Comment to Forest Service on Eversource S-136 rebuild:

The Forest Service decision memo on the S-136 rebuild states:

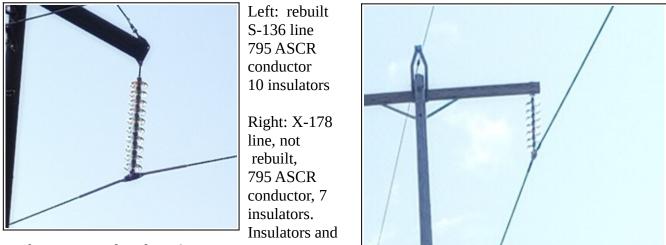
Above: This rip-rap construction pad berm abuts a stream, making access to that stream treacherous and unpleasant. What justification is there for rip-rap to be left alongside a stream in WMNF, when the transmission line terrain was close to natural for more then fifty years and Eversource failed to provide evidence of need for new structures, thus need for any construction?
